Response to RC2 Comments

Barra Peak

March 31, 2025

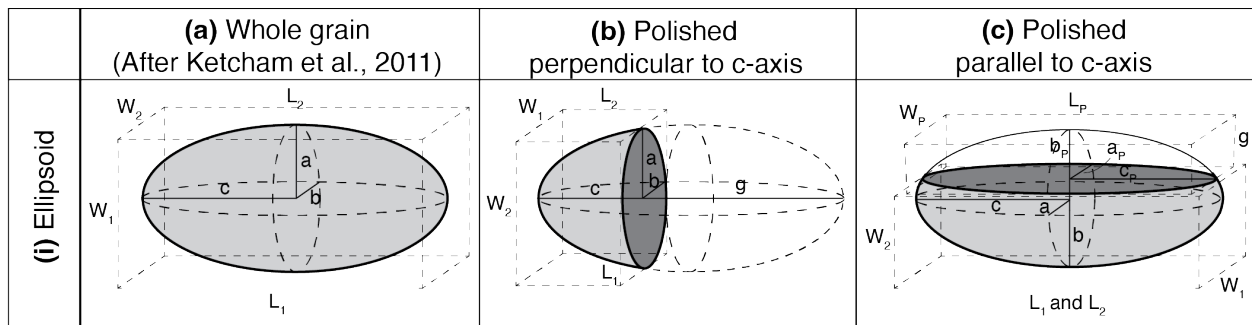
RC2: It's not clear from Fig. 1 what the different labels (e.g. w_1 w_p) are referring to in many of the diagrams.

AC: Thank you for the feedback that this is unclear. W_1 , W_2 , L_1 , and L_2 are the measurements made of the grain while a , b , c , r , and h refer to the axes, semi-axes, radius or height of the idealized geometry. The figure is meant to show visually how these relate to each other to compliment the mathematical relationships between measurements and geometric parameters given in Table 1. Sets of W_1 , L_1 and W_2 , L_2 measurements are made by rotating the grains 90° such that these measurements can also define a rectangular prism that surrounds the grain as in the example below. Does the example better confer the intended relationship? Measurements and parameters axes could also be color-coded to their respective labels.
